Item Raised - Studies

1.3.4 Private Open Space

R4A Low Plate - Studies and line of sight

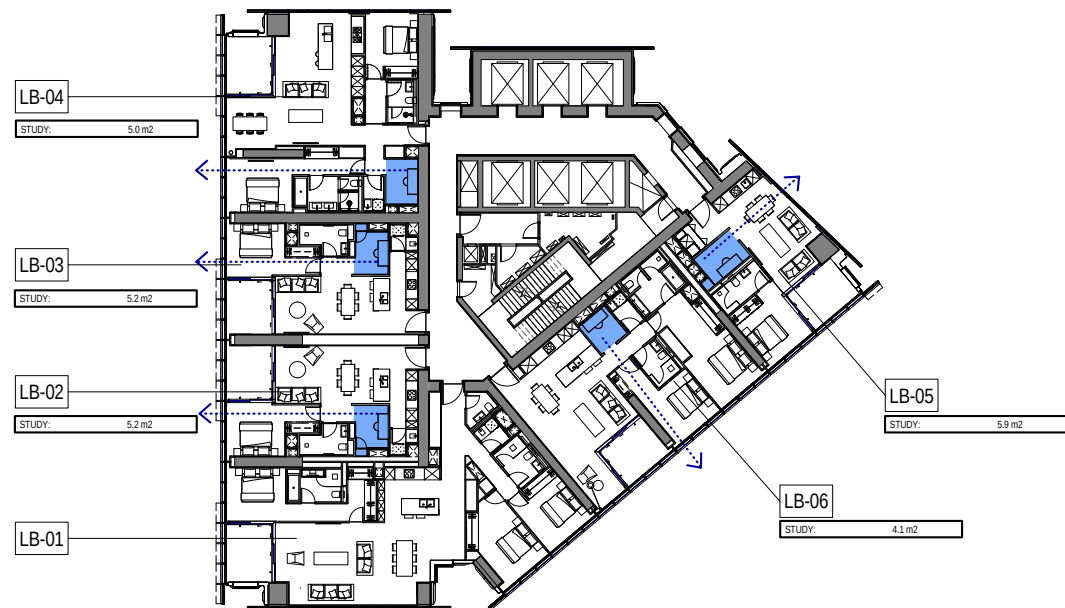
‘Further consideration should be given to exploring alternative designs to improve the amenity of units which do not have study windows or line of sight to a window.’

The internal arrangement of all apartment plans have been reviewed in line with the *Apartment Design Guide (June 2015)* to improve the amenity.

The apartments have been designed to maximise open plan living areas adjacent to the façade and optimise bedroom areas and their outlook. Study provisions have been reduced in area to suit.

Where studies are provided they are designed to provide ultimate flexibility for the apartment, be it a work from home area or an extension of the master suite or providing opportunity for additional storage.

All apartment plans have been amended to provide a line of sight to a window.

L5-01 & M5-01 Balcony Plan and Section - Scenario A

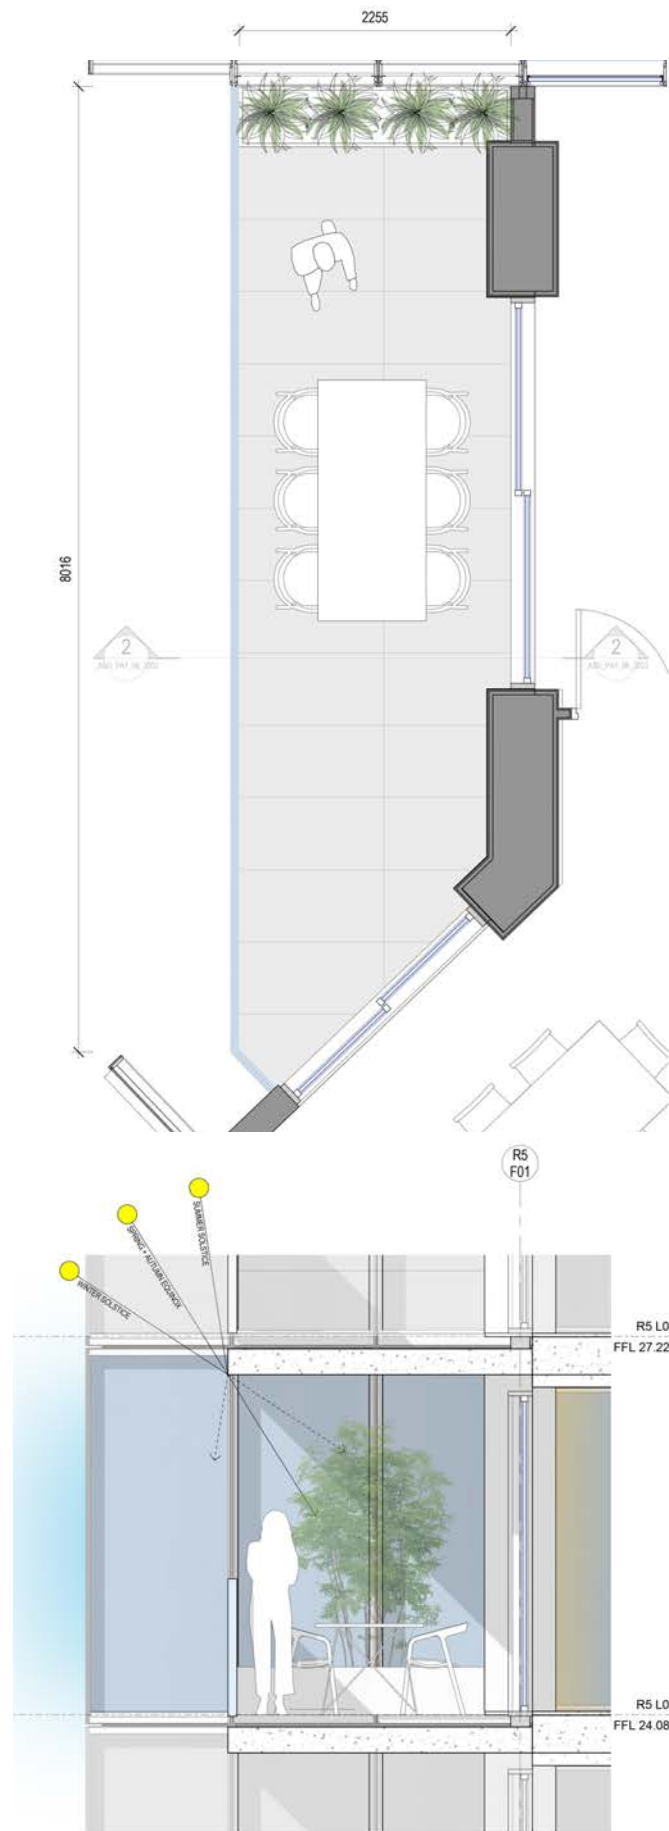
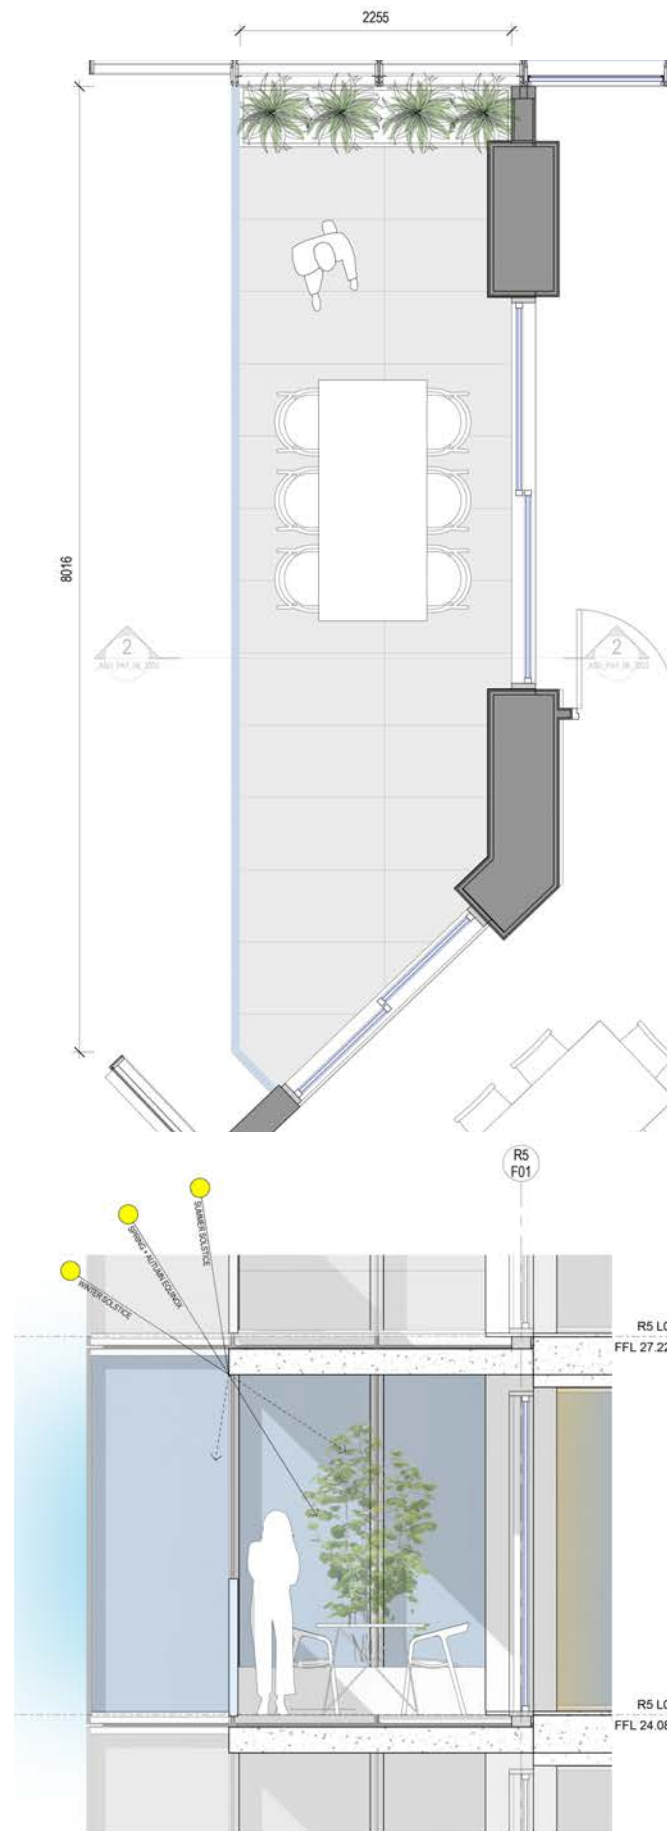
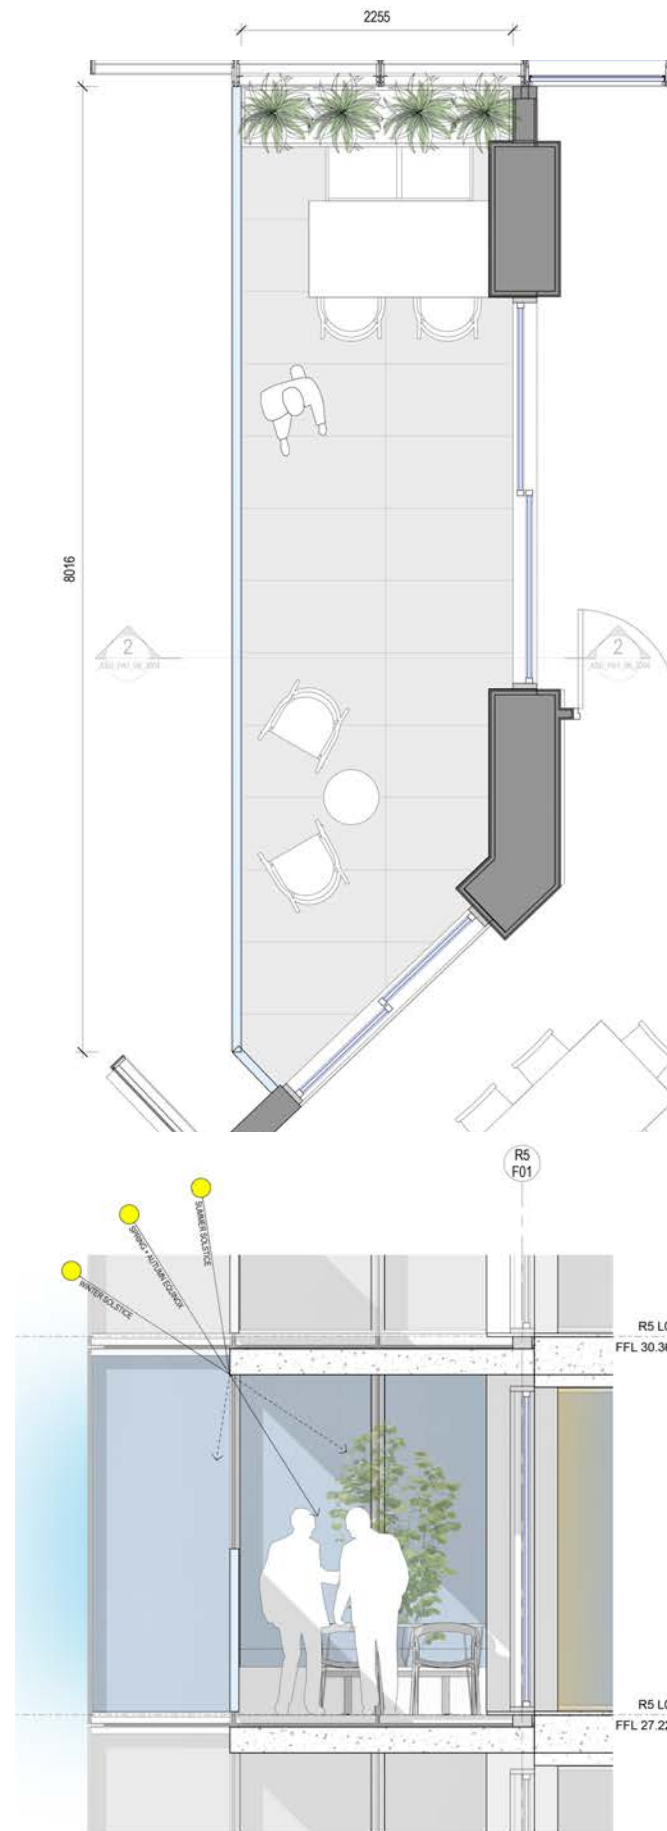
‘Further consideration should be given to increasing the size and/or depth of balcony / wintergardens for three bedroom units to comply with minimum Apartment Design Guide requirements.’

The depth of the balcony / wintergardens to the three bedroom apartments is 2.7m and exceeds the minimum requirement of 2.4m.

The balconies and wintergardens have been designed as an extension of the open plan living areas with flush thresholds and an equal level of material finish.

The overall dimensions of the balconies and wintergardens have been considered to allow for a range of uses whilst taking into account environmental conditions.

All balconies and wintergardens can be comfortably furnished to suit a number of scenarios as per the adjacent diagrams.

Storage Cage Floor Plan

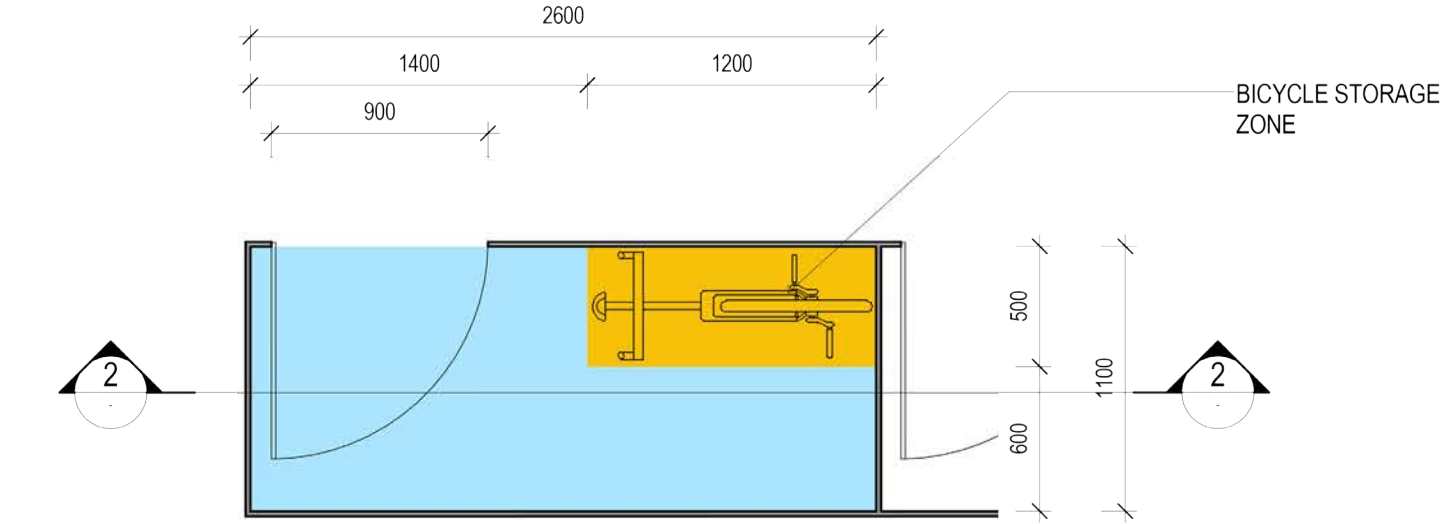
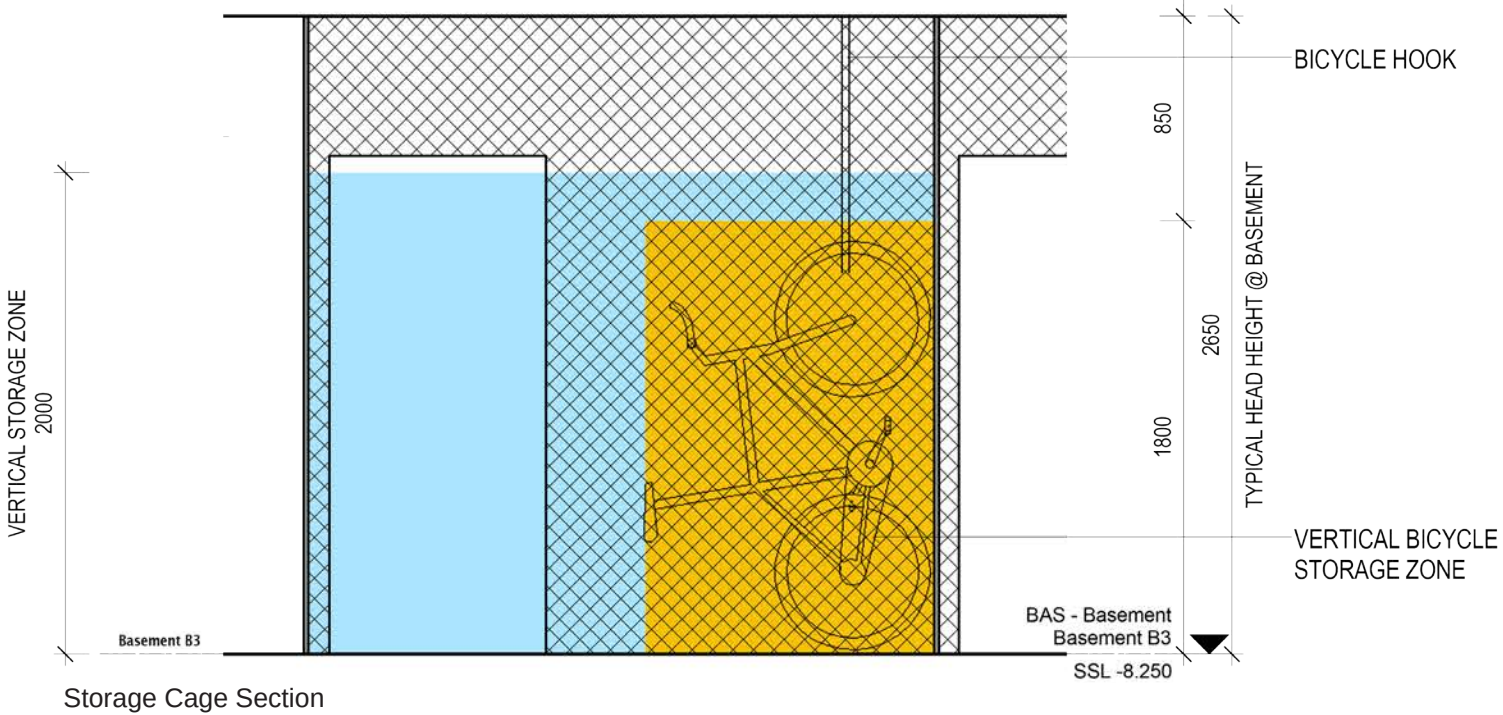
‘Provide more detailed information to demonstrate compliance with storage requirements. This includes within units and within the basement. Bicycle storage should not be provided within individual storage cages unless the volume of each cage is increased accordingly.’

Bicycle storage has been provided within lockable cages located within a secure area of the basement that is dedicated for residents, and accessible only by swipe card. As the Australian Standards (AS) classify bicycle parking by the level of security provided, this development’s provision of bicycle storage is aligned with class B, which is generally described as a secure structure that is part of the destination, is protected from the weather, has locking mechanisms provided for individual cages within the structure, and has entrance gates to the secure area are self-closing and self-locking.

The volume of the basement cages are of varying sizes with the minimum volume being 5.72m3. If this size cage was provided to the apartment with the smallest amount of storage volume included within the apartment the storage volume after deducting the volume of the bicycle is still greater than the minimum storage capacity required by the *Apartment Design Guide (June 2015)*. The diagrams depict the minimum storage cage size, demonstrating how the cage will accommodate a bicycle and meet the objective.

Views taken from the sun's position throughout June 21

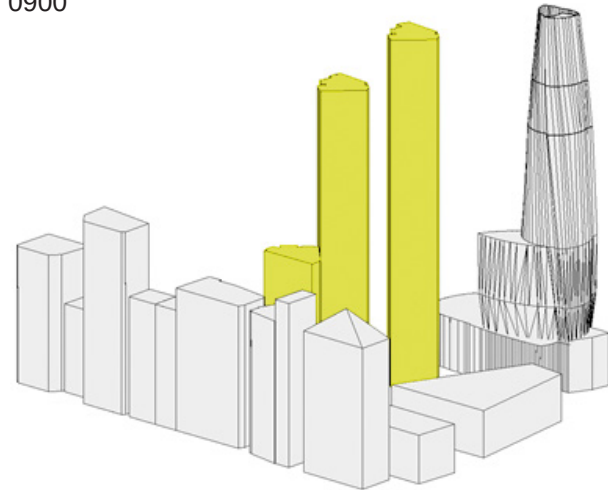
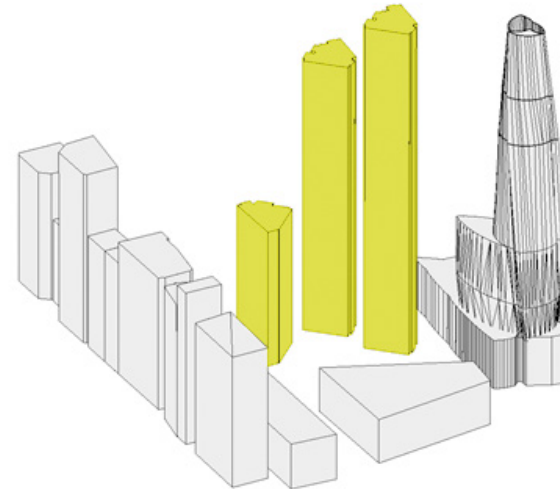
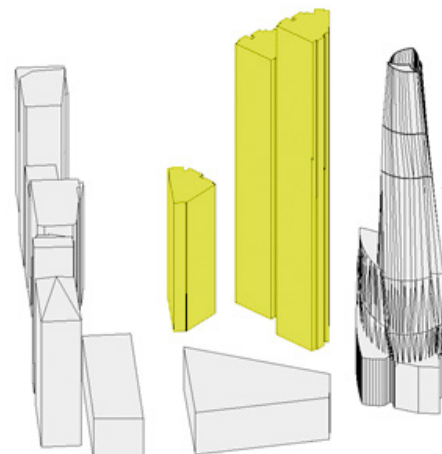
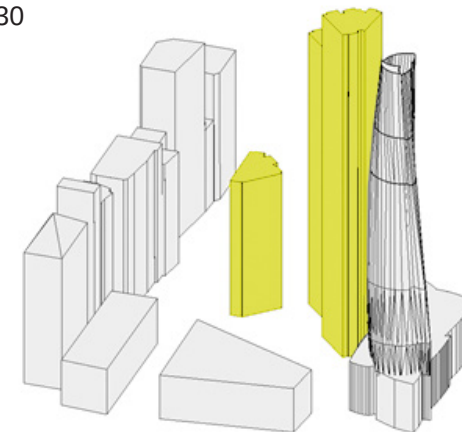
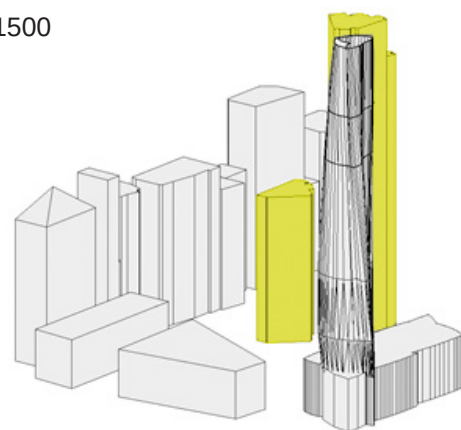
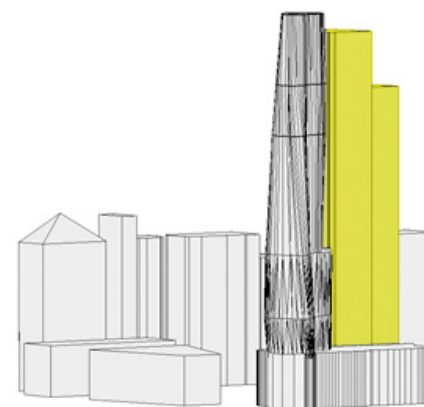
‘Further consideration should be given to the layout and configuration of units to improve opportunities for solar access for the development. In particular, the number of units receiving direct sunlight between 9am and 3pm in midwinter should be reviewed. In addition, the number of units within R4B that do not receive direct sunlight between 9am and 3pm in midwinter should also be reviewed.’

Solar access has been re-modelled with increased accuracy by introducing additional representative floors and apartments, beyond that of the initial modelling. A full solar report detailing the analysis of solar and daylight access across the individual buildings is included as part of the submission. The results of this report are briefly discussed here, and a schedule noting the number of hours each apartment receives is at Appendix A.

The total development achieves reasonable solar access for a site located within the density of the Sydney Metropolitan Area, with excellent daylight access due to the highly transparent façade and north-east and west orientation of all three buildings. Across the development, 66% of the apartments receive 2 or more hours of direct sunlight between 9am-3pm for living rooms and private open space during the winter solstice.

In addition, with the location of the buildings being near the western harbour edge, apartments will also receive sunlight at low solar altitudes. For this reason results have been presented for an extended time frame beyond 3pm. This approach is consistent with what was approved for Residential Buildings R8 and R9 at Barangaroo South. Sun perspective diagrams have been included to illustrate the duration of solar access the buildings receive. These diagrams are modelled from the perspective of the sun based on 21 June. Under the extended solar time-frame of 9am-4.45pm, 85% of apartments across the development receive 2 or more hours of direct sunlight to living rooms and private open space during the winter solstice.
